Sag Harbor

ORIGINAL Suite
Suite 412

Suite 412 - Inventory Suite

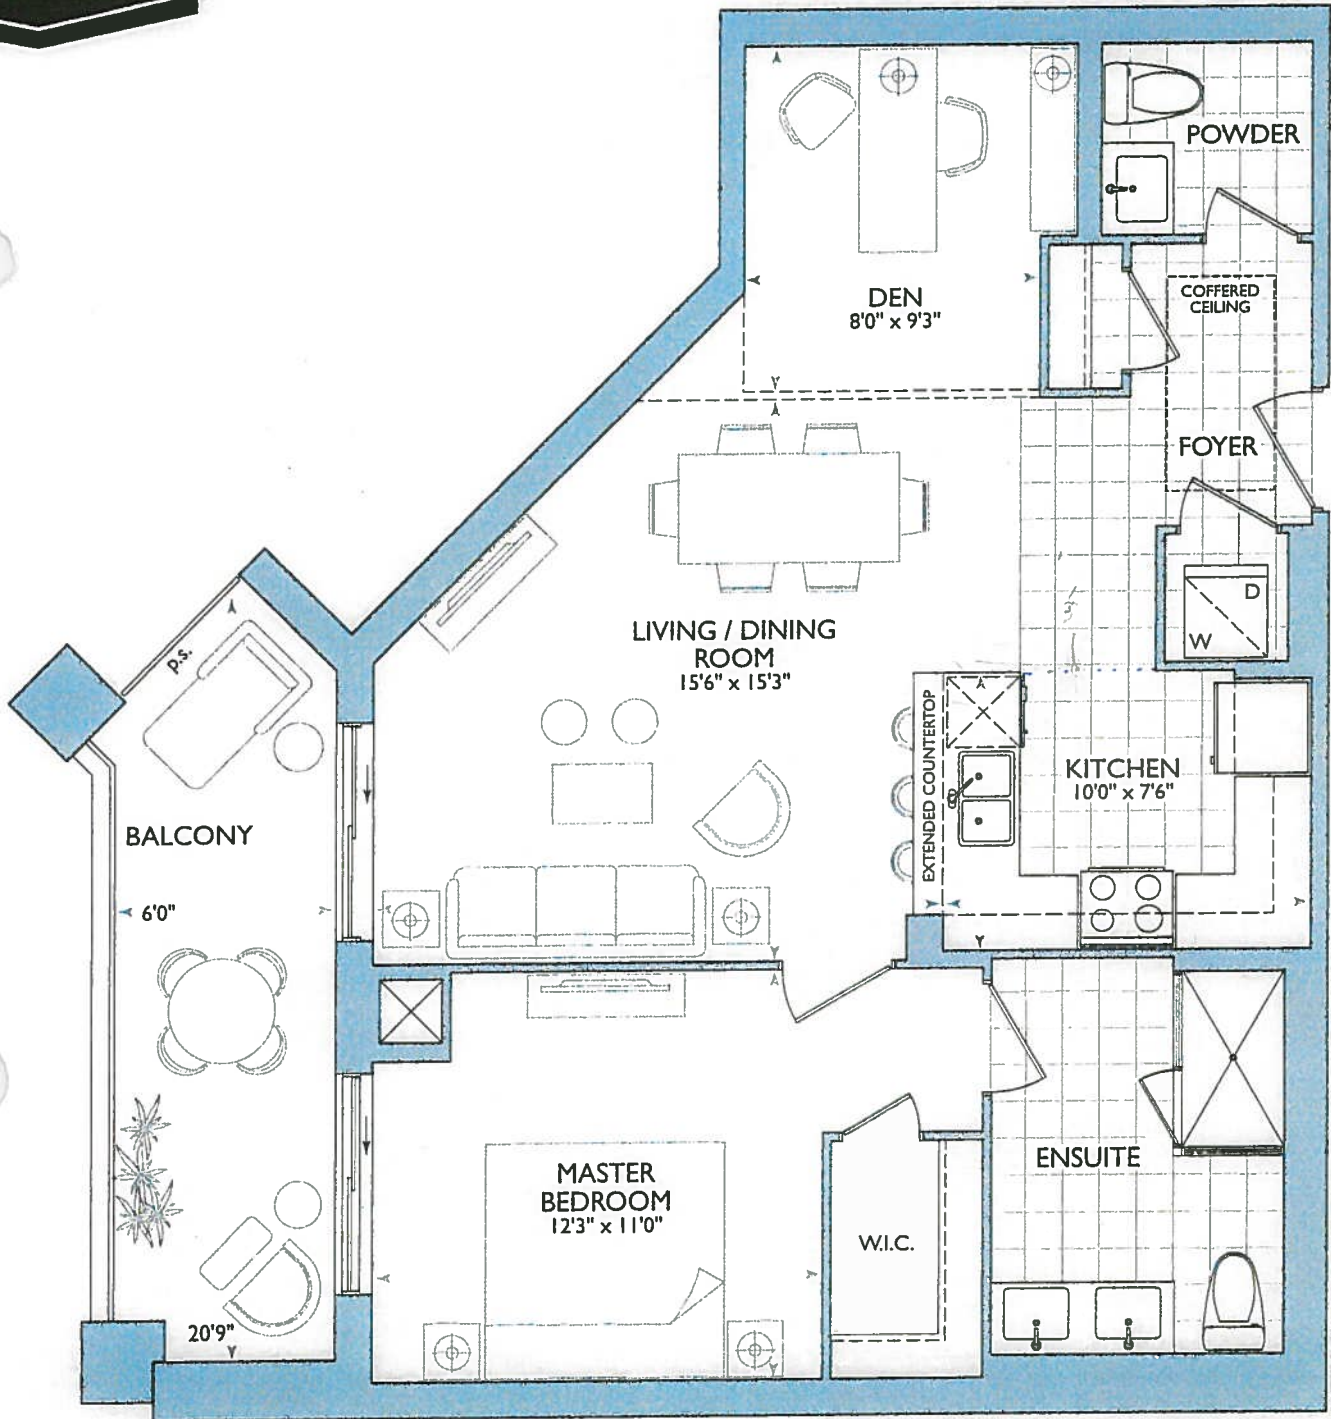
Move front door - Due to 6" wall too far behind w/d.

Kitchen

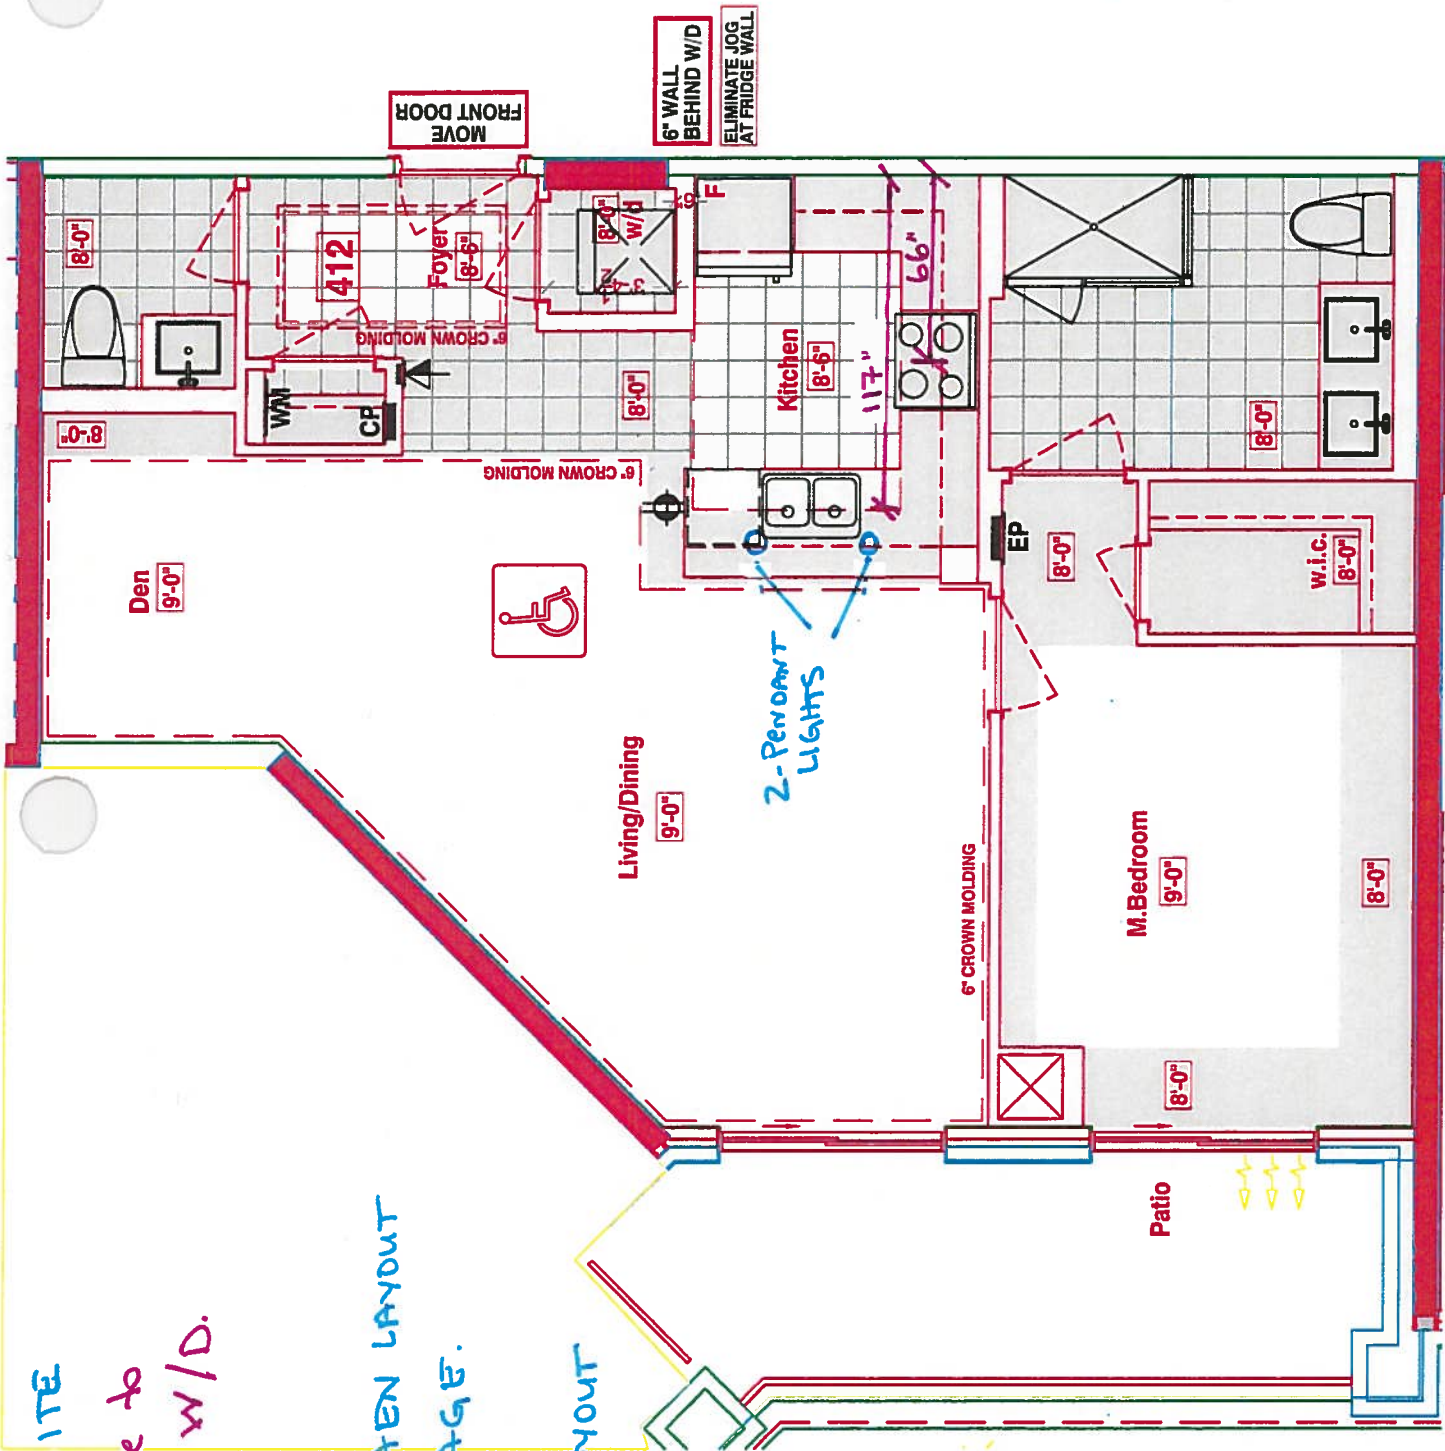
Option of using std kitchen layout w/ std appliance package.

OR

1st upgrade kitchen layout w/ 1st upg appliance package

(P) = Plug peninsula

2x = pendant lights

(see both kitchen layout options)

66" stove pipe center

117" sink pipe center
